### APPEAL SUMMARY

<b>Appeal ID:</b> 23399	<b>Project Address:</b> 4451 NE 42nd Ave
<b>Hearing Date:</b> 2/5/20	<b>Appellant Name:</b> Melissa Meiners
<b>Case No.:</b> B-003	<b>Appellant Phone:</b> 503 708-2157
<b>Appeal Type:</b> Building	<b>Plans Examiner/Inspector:</b> Steven Mortensen
<b>Project Type:</b> commercial	<b>Stories:</b> 3 <b>Occupancy:</b> R-2 <b>Construction Type:</b> V-B
<b>Building/Business Name:</b> Society 42	<b>Fire Sprinklers:</b> Yes - Throughout Building
<b>Appeal Involves:</b> Erection of a new structure	<b>LUR or Permit Application No.:</b> 19-247186-CO
<b>Plan Submitted Option:</b> pdf [File 1]	<b>Proposed use:</b> Apartments

SOCIETY 42

STAIR 2 - PLANS & SECTIONS

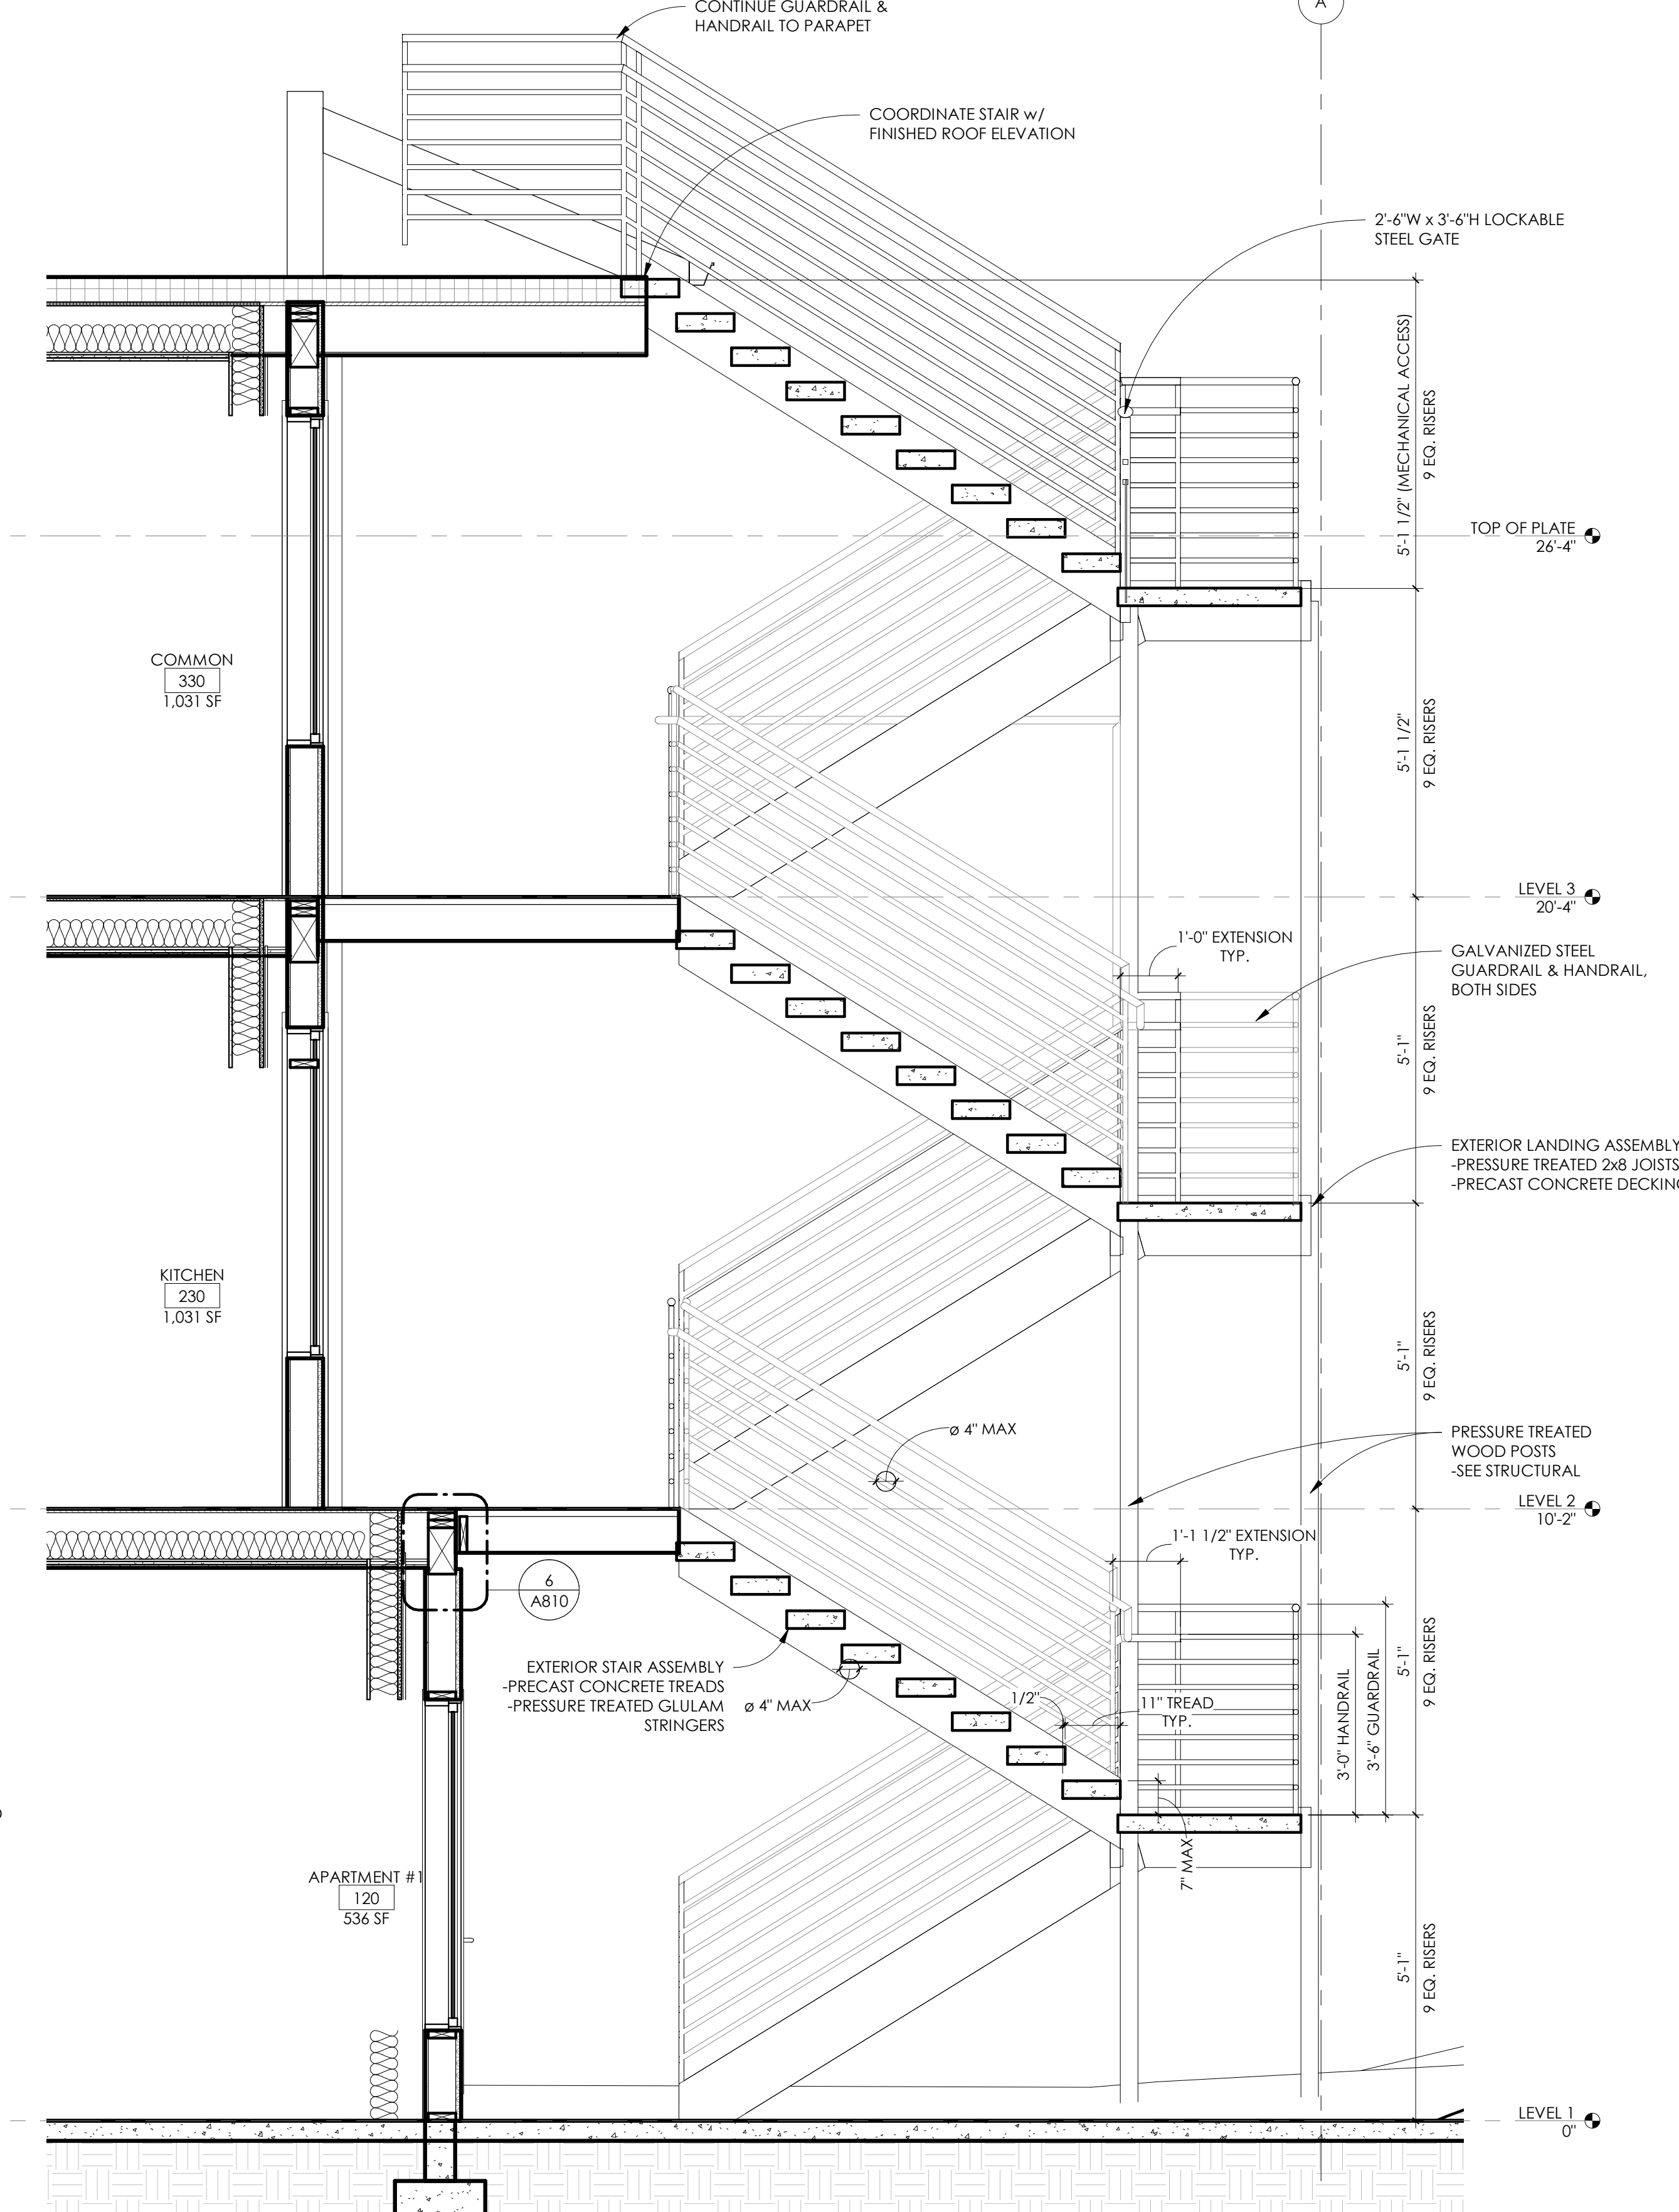
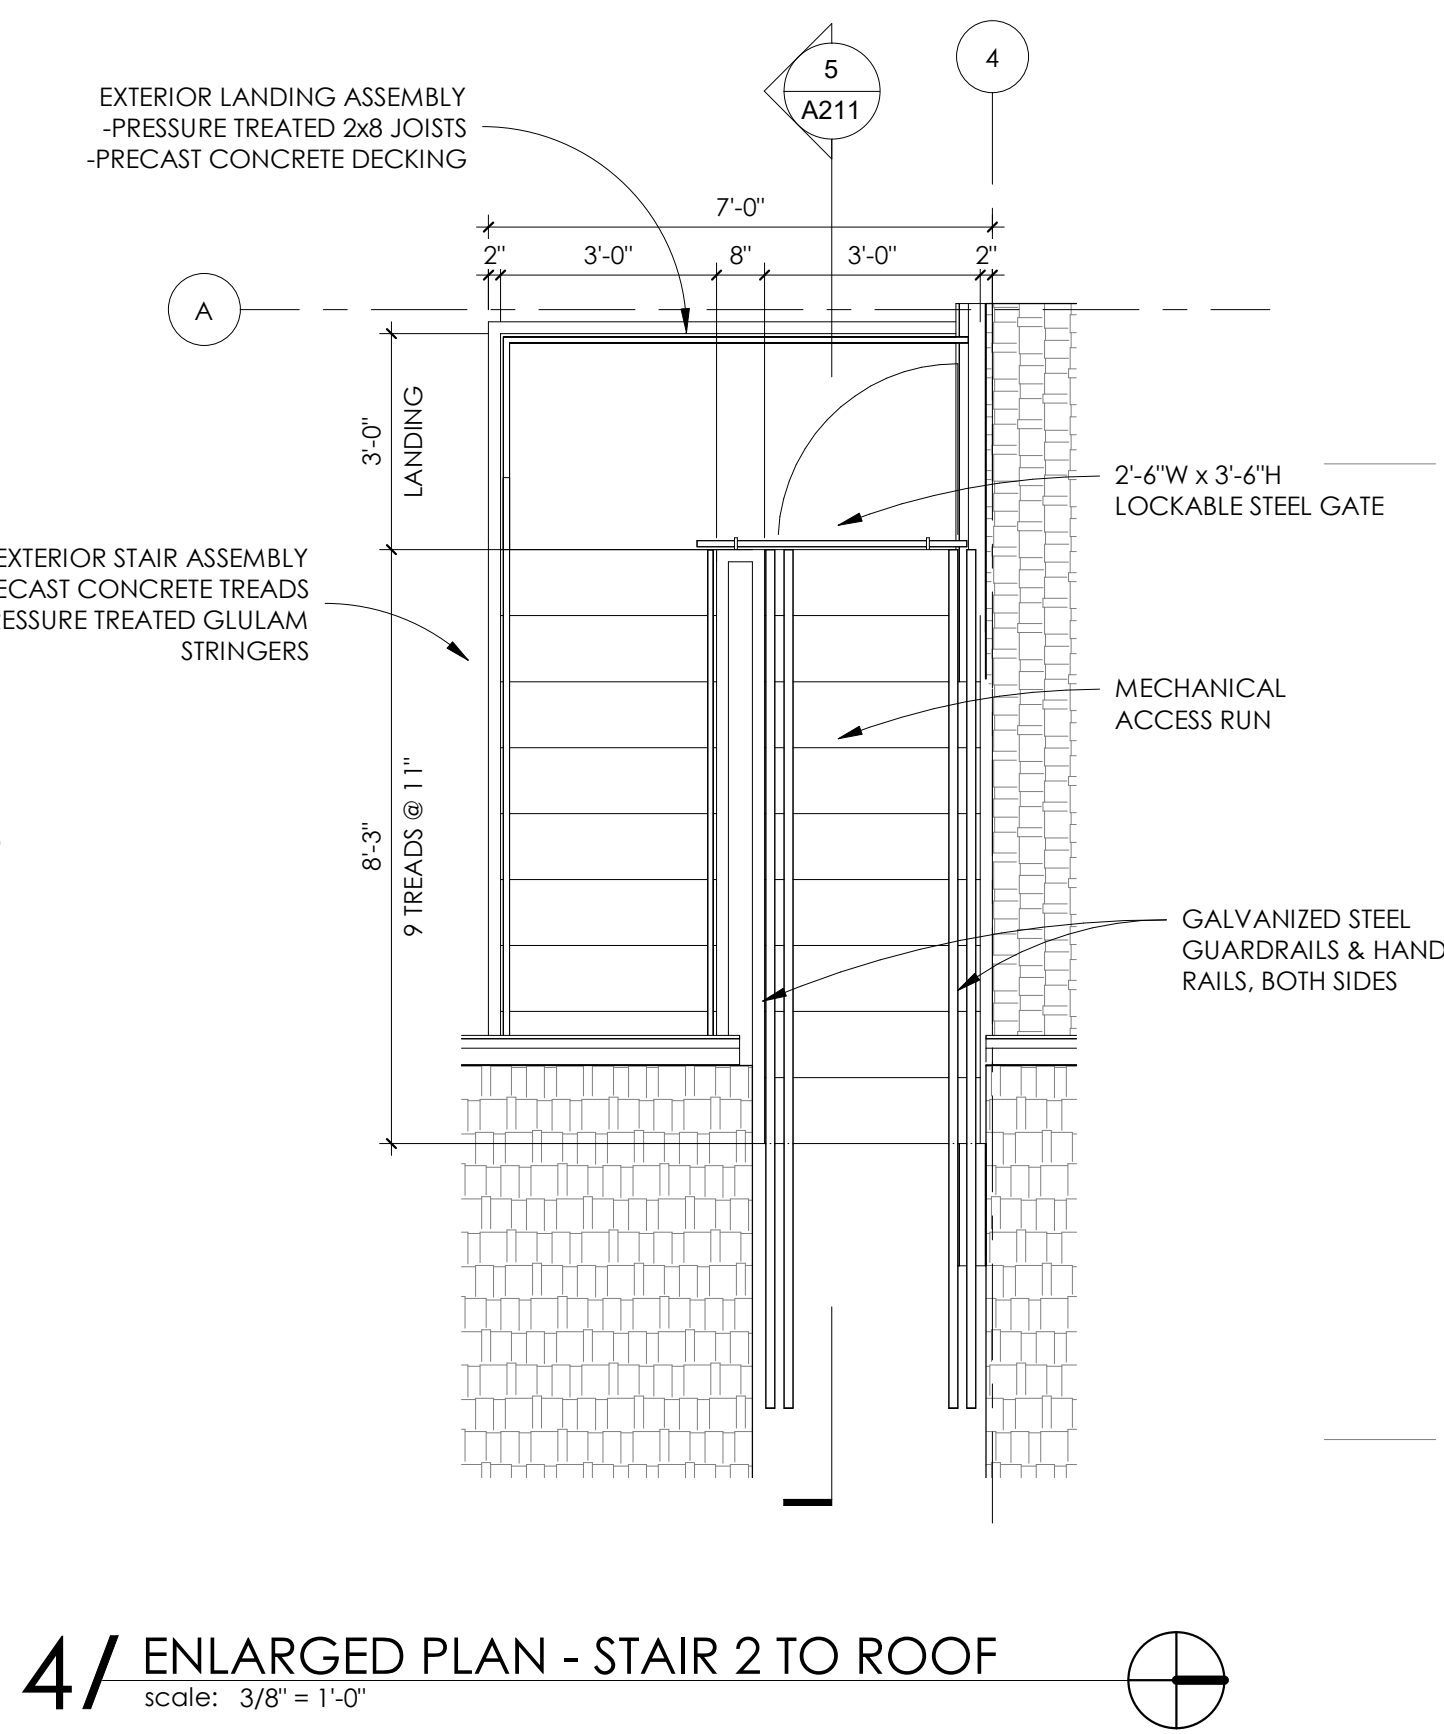
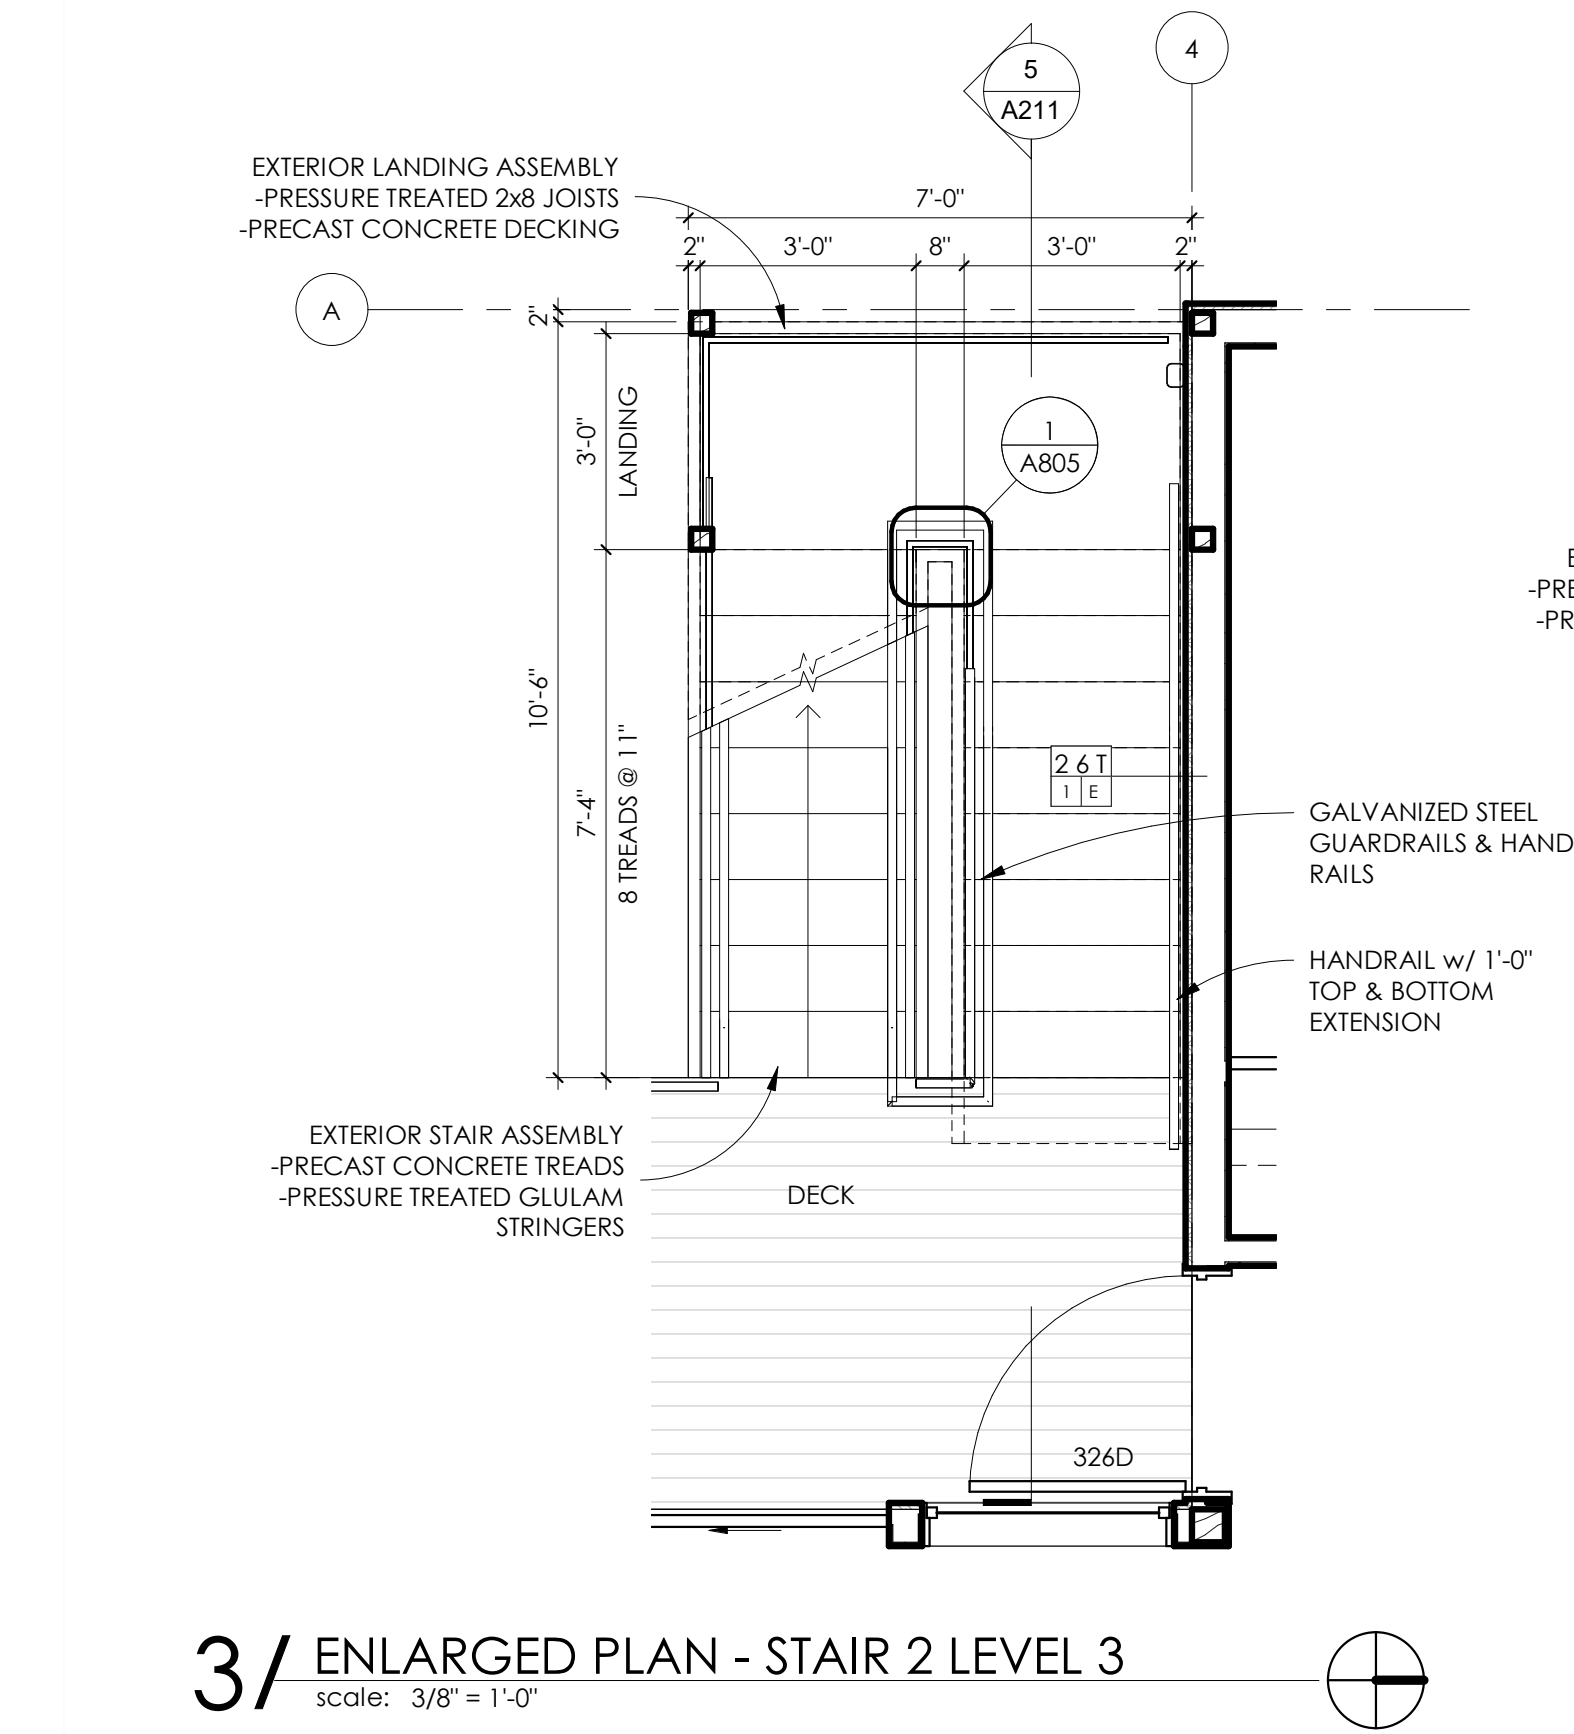
<b>Reason for alternative</b>	<p>Exterior Exit Stairway #2 – The south handrail extension at the bottom riser of this stair is proposed to turn 180 degrees, in the same way handrails return at the continuous inner handrails between flights of stairs. This will alleviate the pinch point at grade between the handrail and building wall. Turning the handrail extension 180 degrees will also lead occupants around the stairs and towards the egress court when exiting.</p> <p>North Exterior Stair #4 - The straight, continuous 12" extension would extend into the ROW and require an encroachment permit from PBOT. The handrails still provide a continuous gripping surface that lead building occupants to grade when exiting.</p> <p>Similar appeals have been granted. See appeals #18642, 18187, 18922 and 18798.</p> <p>The applicant requests that the handrail extension for the Exterior Exit Stairway #2 be permitted to turn 180 degrees.</p> <p>The applicant requests that the handrail extensions for the North exterior stair #4 be permitted to turn 90 degrees.</p>

APPEAL ITEM 3 -  
HANDRAIL EXTENSION TURNS 180 DEGREES.  
SIMILAR CONDITION TO INNER HANDRAIL

**3a. Omission of full 12 inch horizontal handrail extension: Denied. Proposal does not provide equivalent Life Safety protection.**

**3b. Stair 2 bottom handrail extension to wrap 180 degrees: Granted as proposed.**
